Stormwater Detention and Infiltration Design Data Sheet

Stormwater Facility Name: Pond A2

Facility Location & Jurisdiction: Overlook Filing No. 1- El Paso County

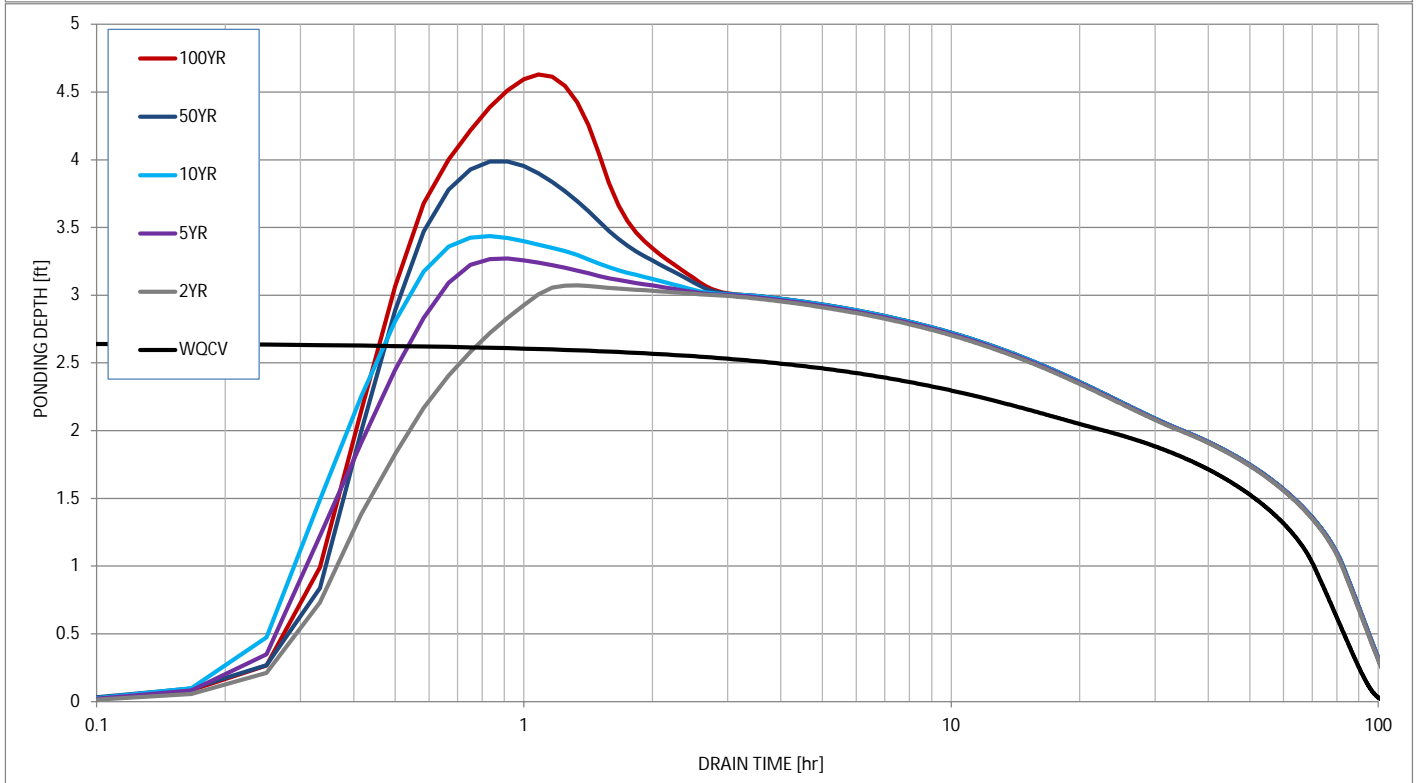
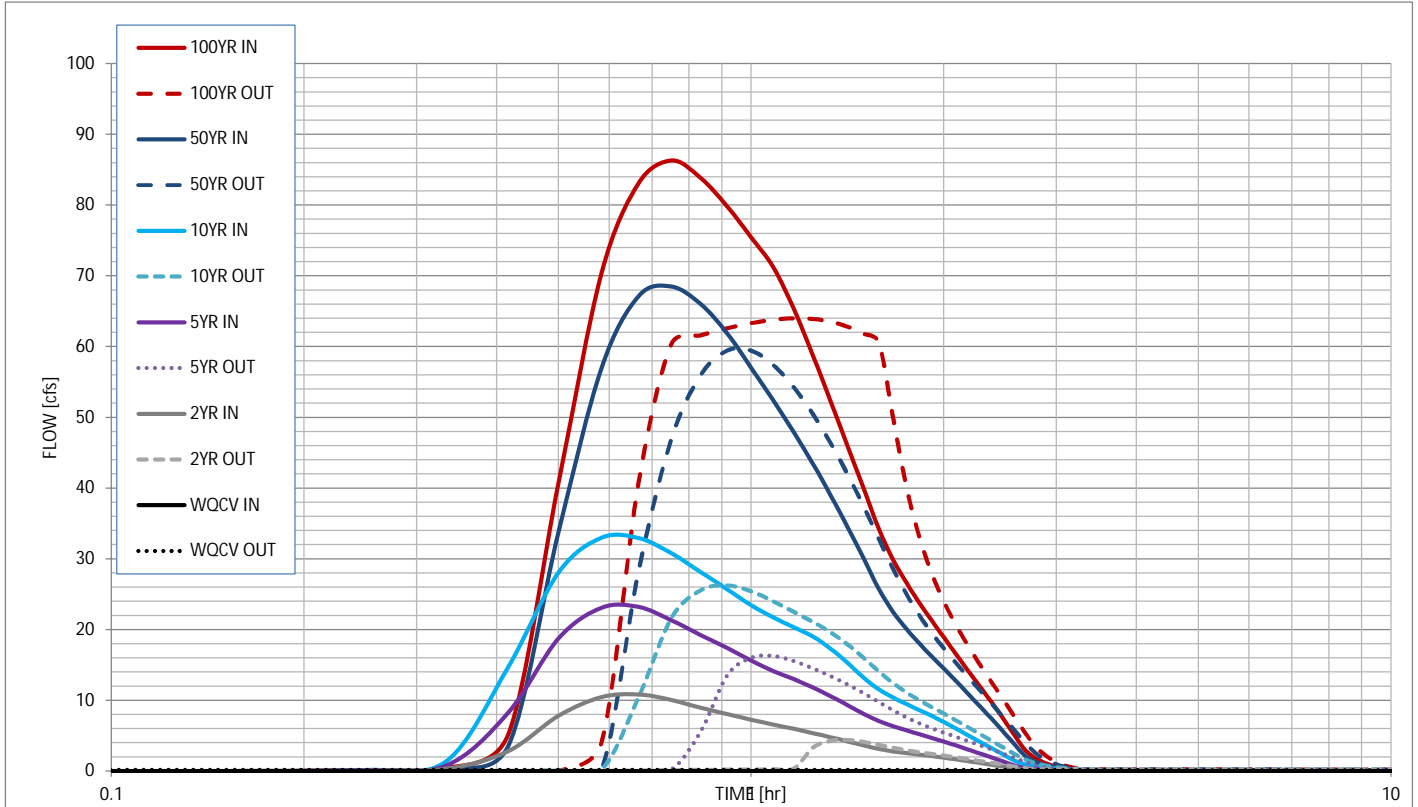
Unresolved from
Submittal 1: These
don't match the
MHFD spreadsheet in
the drainage report.
